Title: ERID-111328 SUBMITTAL OF THE RESPONSE TO THE NOTICE OF DISAPPROVAL FOR THE INVESTIGATION WORK PLAN FOR LOWER PAJARITO CANYON AGGREGATE AREA AND REVISION 1, INCLUDING 2 CD'S, EP2010-0521, EP2010-0522, LA-UR-10-7635

To:(Addressees - Organization) JAMES BEARZI, NMED

From:(Senders - Organization) MICHAEL J GRAHAM, LANL
 GEORGE J RAE, DOE

Figure 4.2-2 Proposed sampling locations for SWMU 18-012(b)

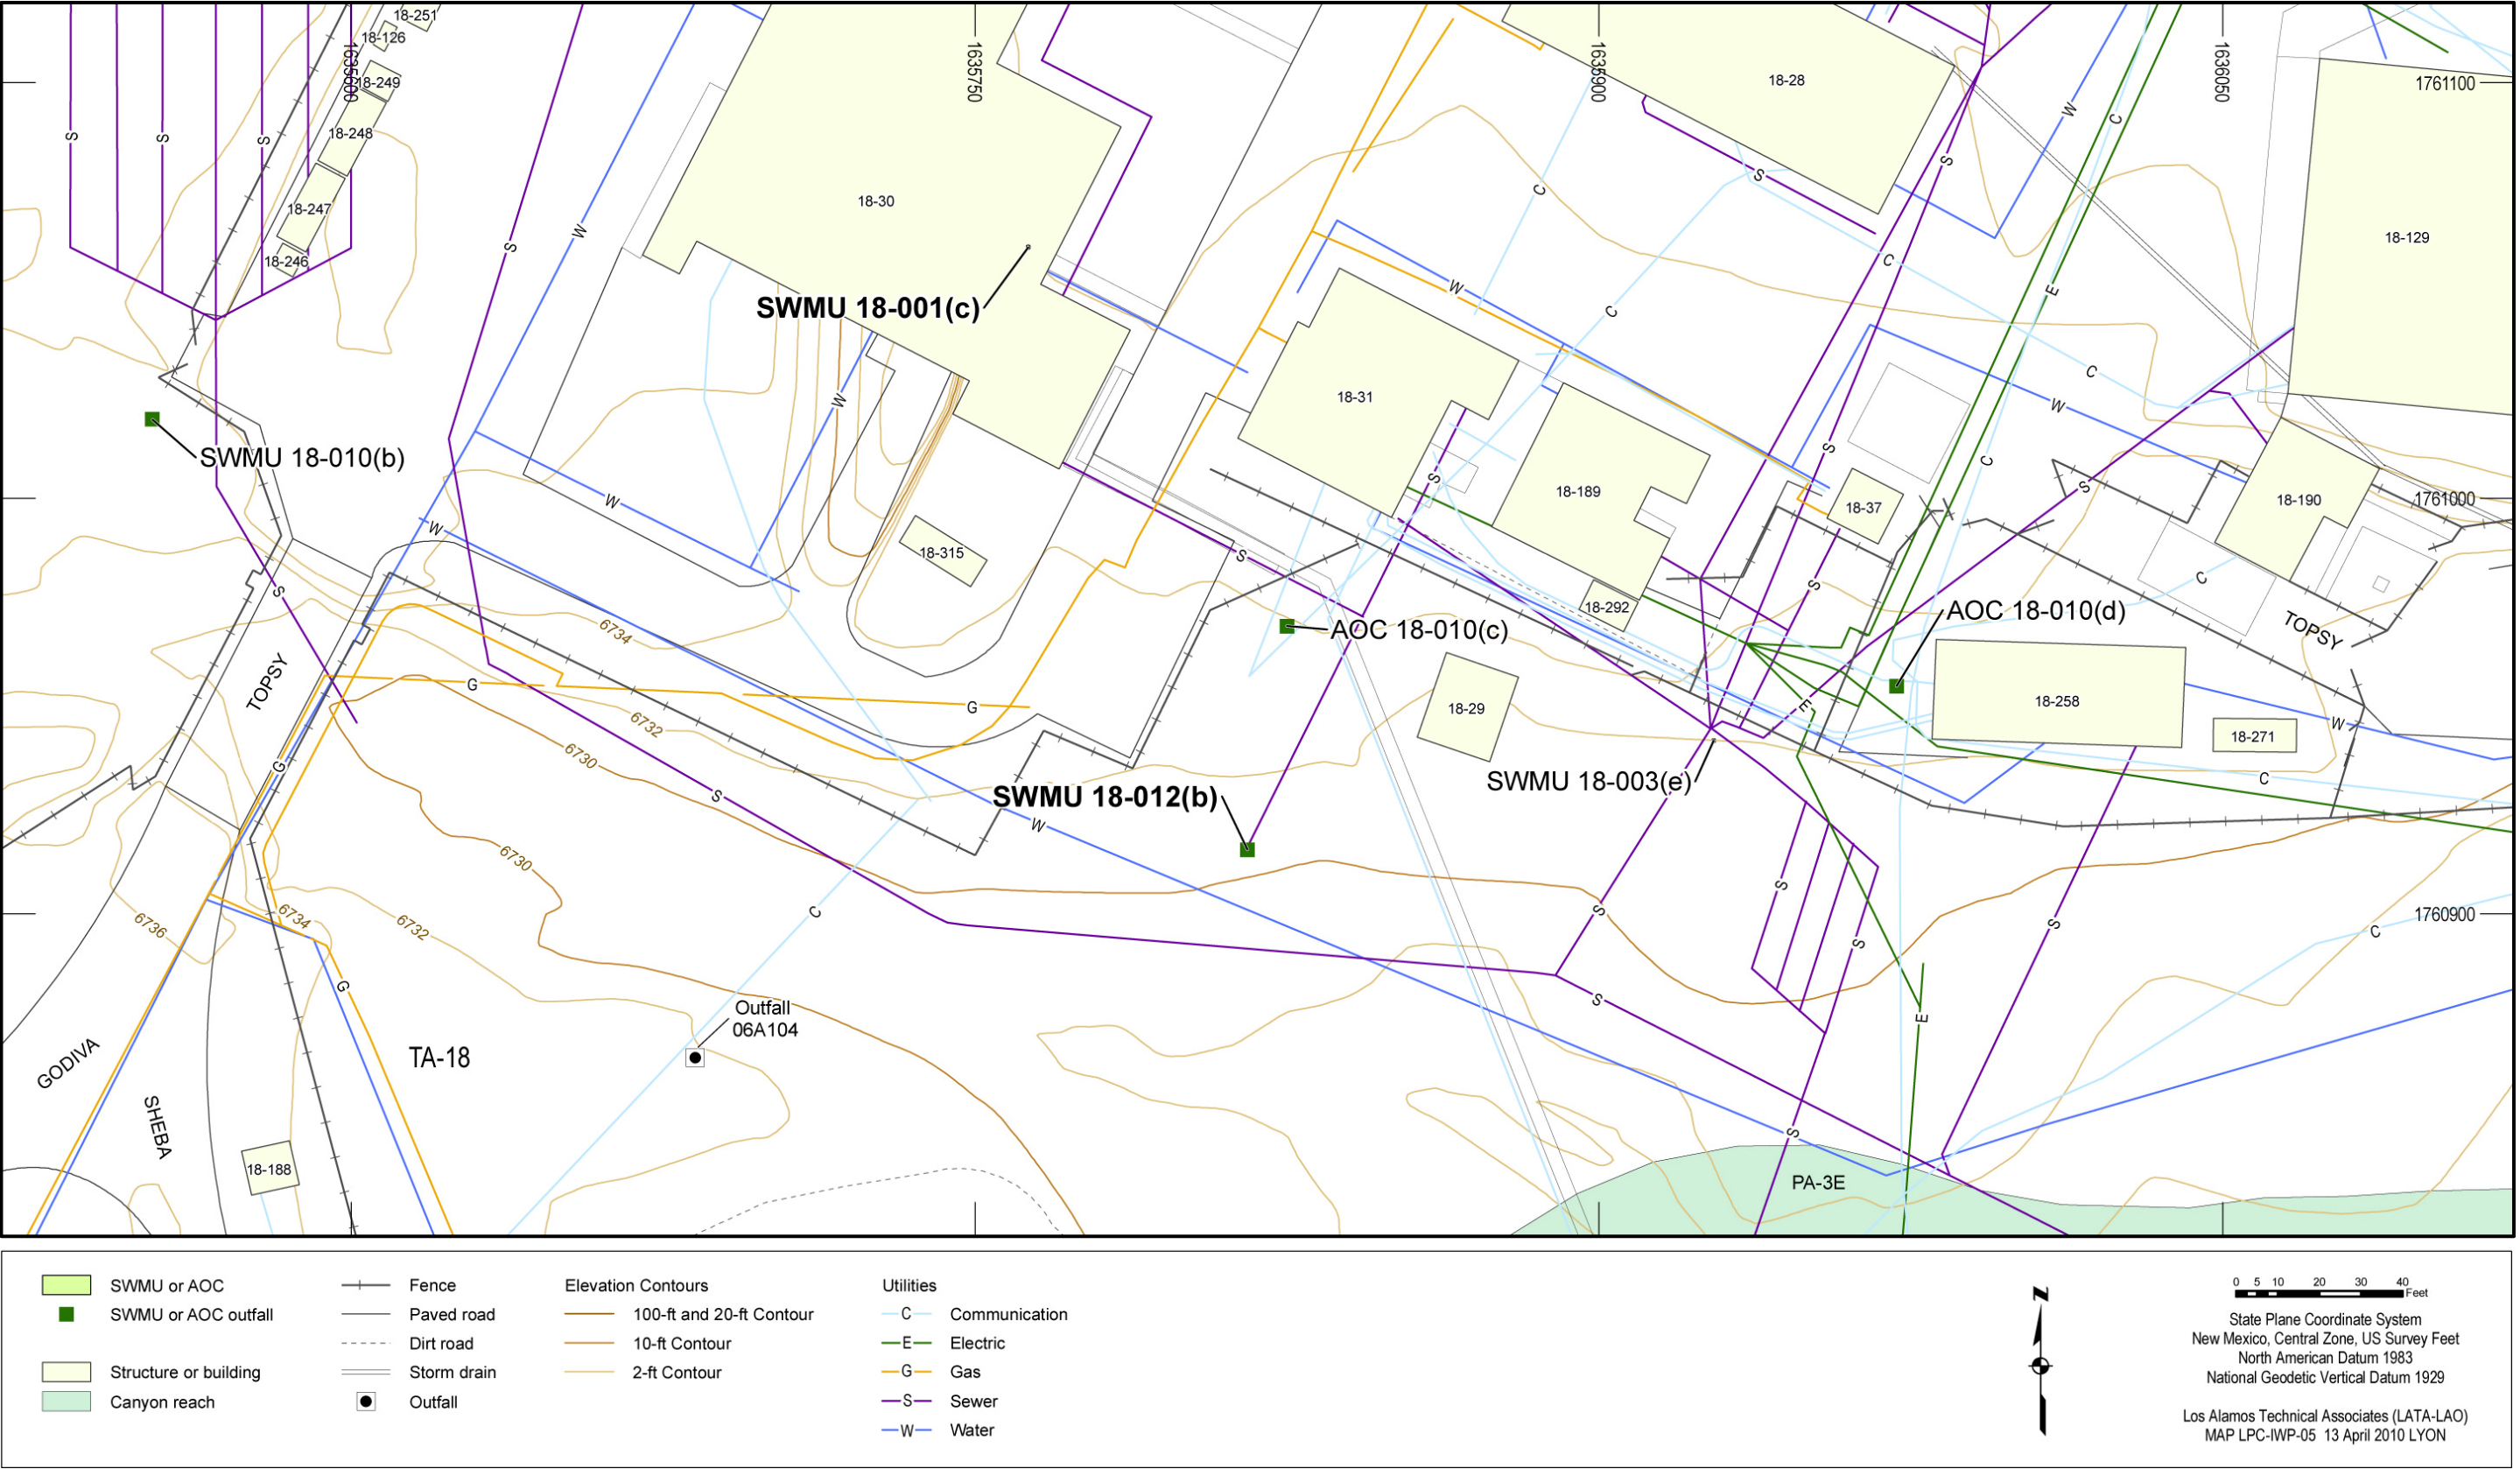
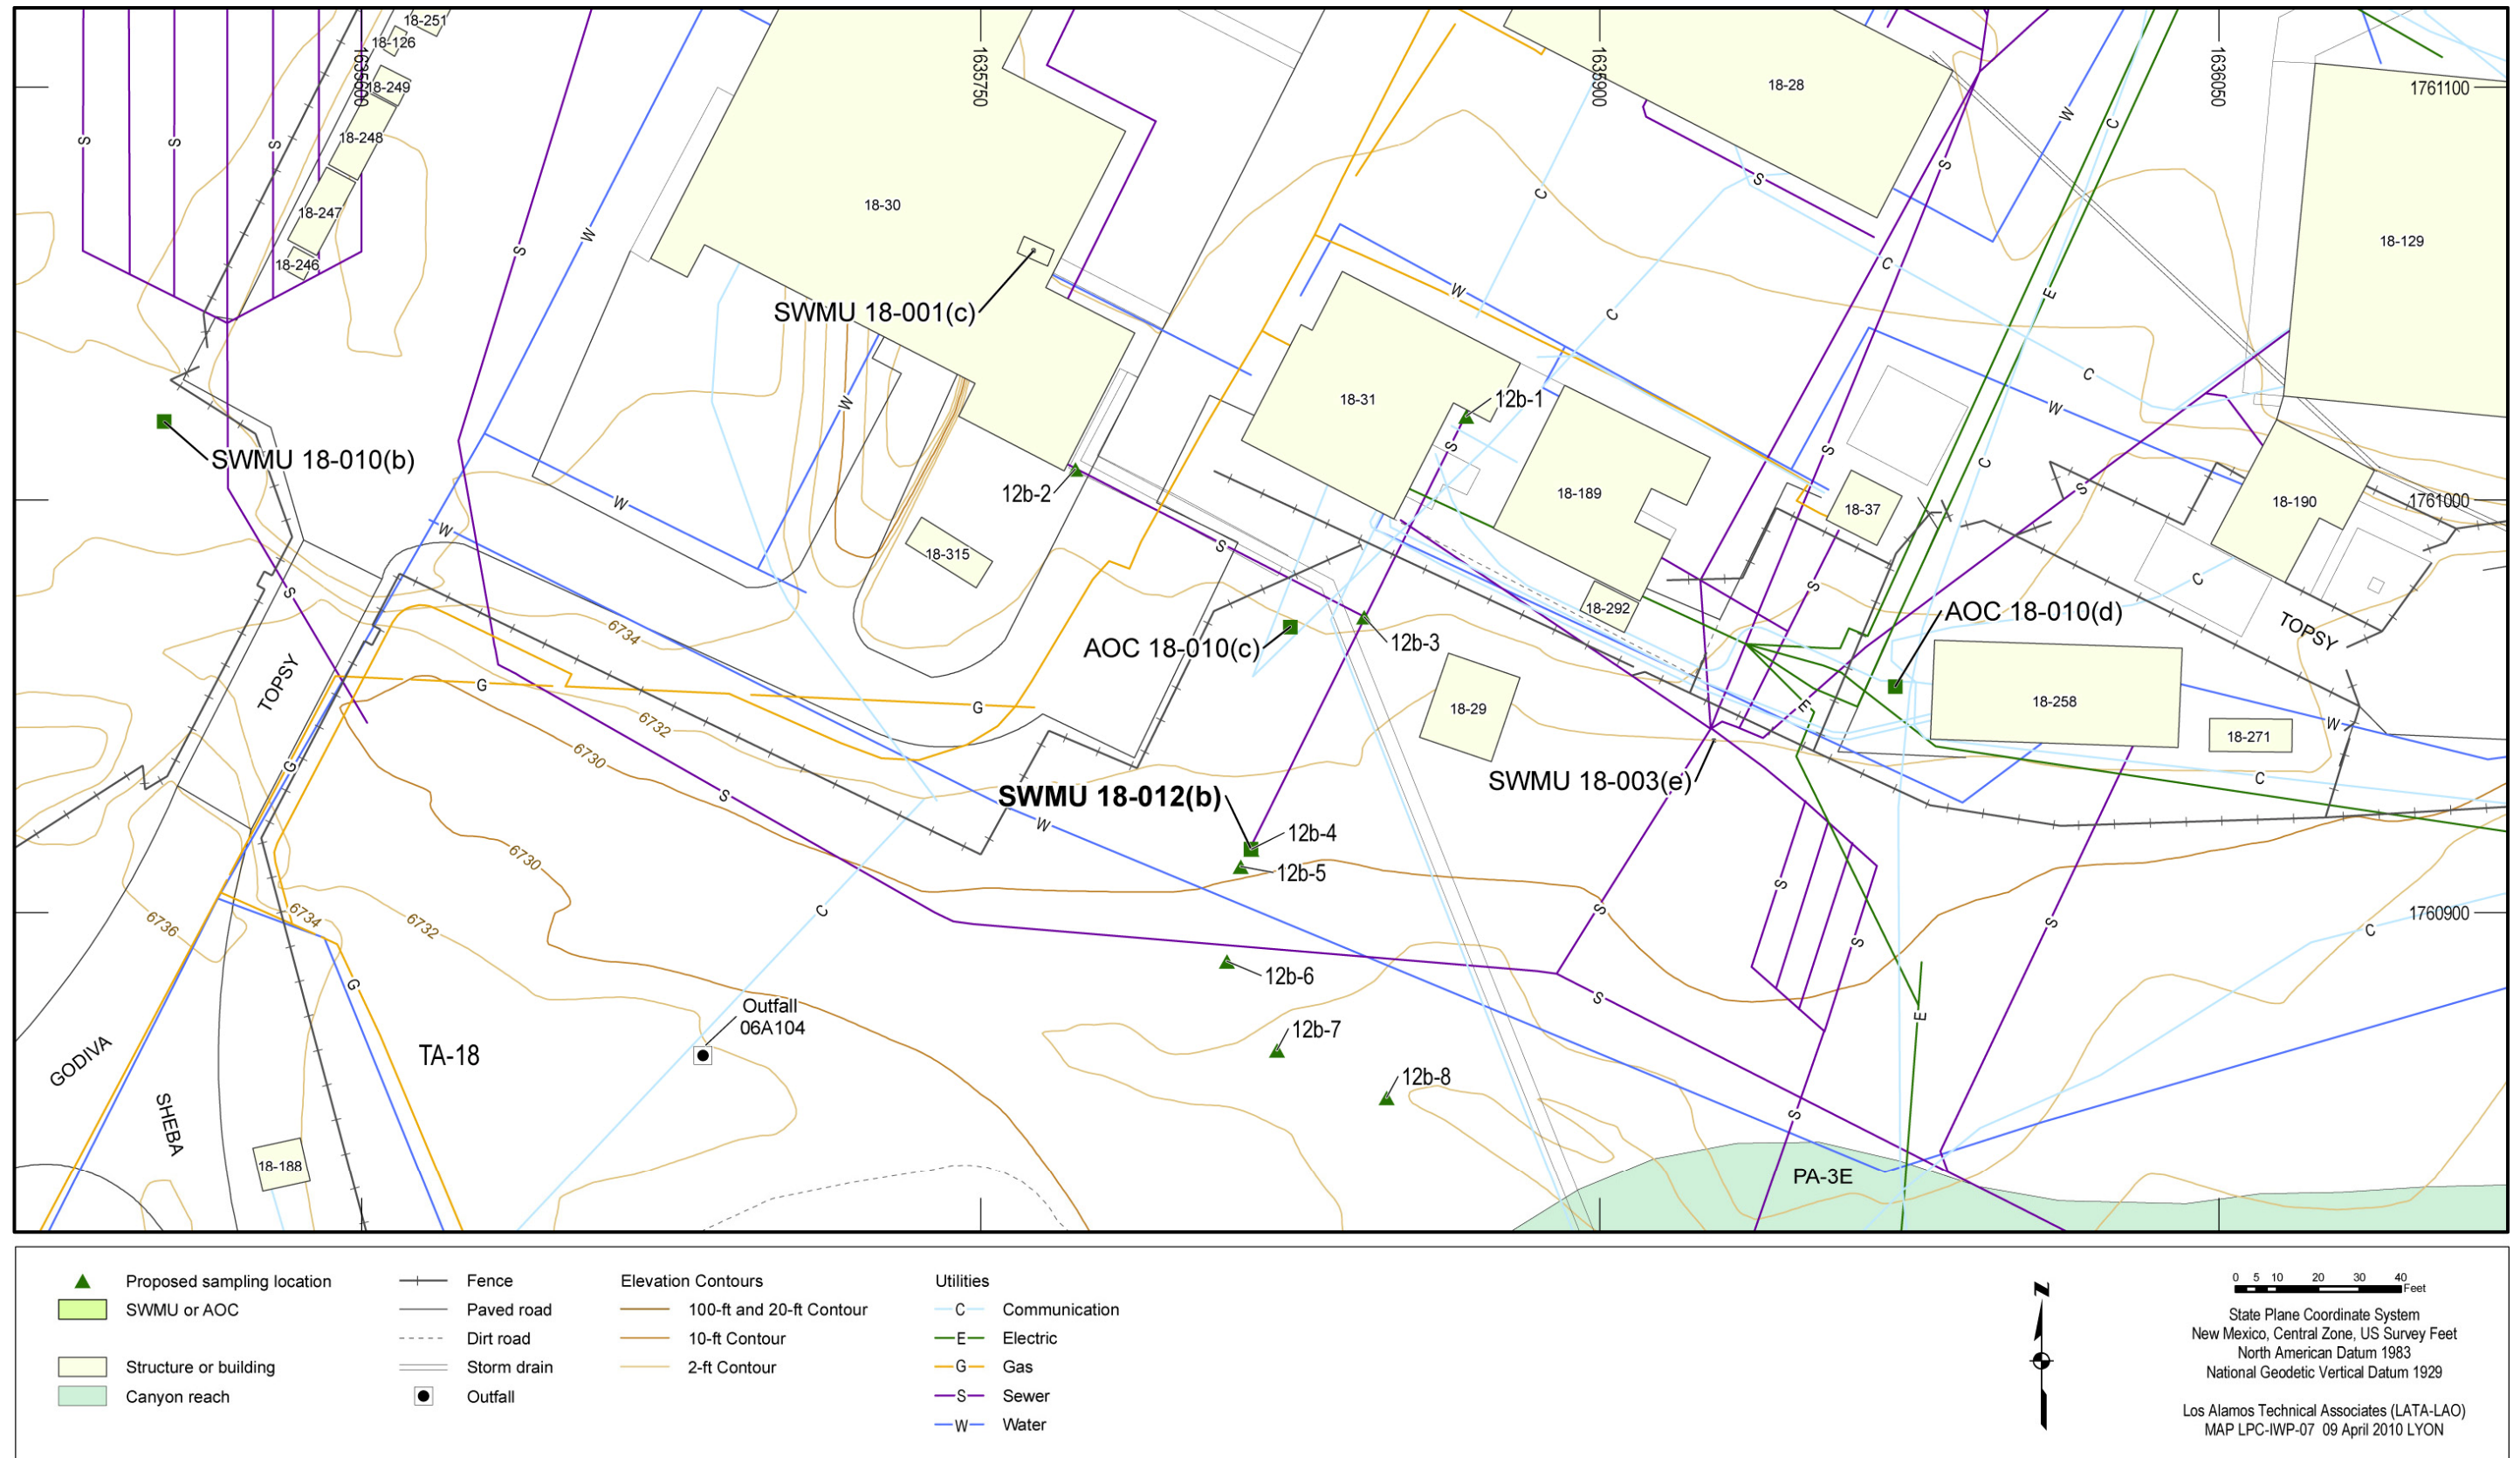
7. **Section 4.2.2.3, Scope of Activities for SWMU 18-012(b), page 18 and Figure 4.2-2, Proposed sampling locations for SWMU 18-012(b), page 72:**

There is another drain line shown on Figures 4.2-1 and 4.2-2. It runs in an east-southeast direction and it appears to originate from the southeast corner of Building 18-31. The line is not mentioned in the text and it is not clear on the figure whether or not it is connected to the line that serviced

7. Text in section 4.2.2.3, Figure 4.2-2, and Table 4.2-1 have been revised to include three additional proposed sampling locations. Two locations were added where the drainlines exit buildings 18-30 and 18-31, and a third location was added at the line junction.
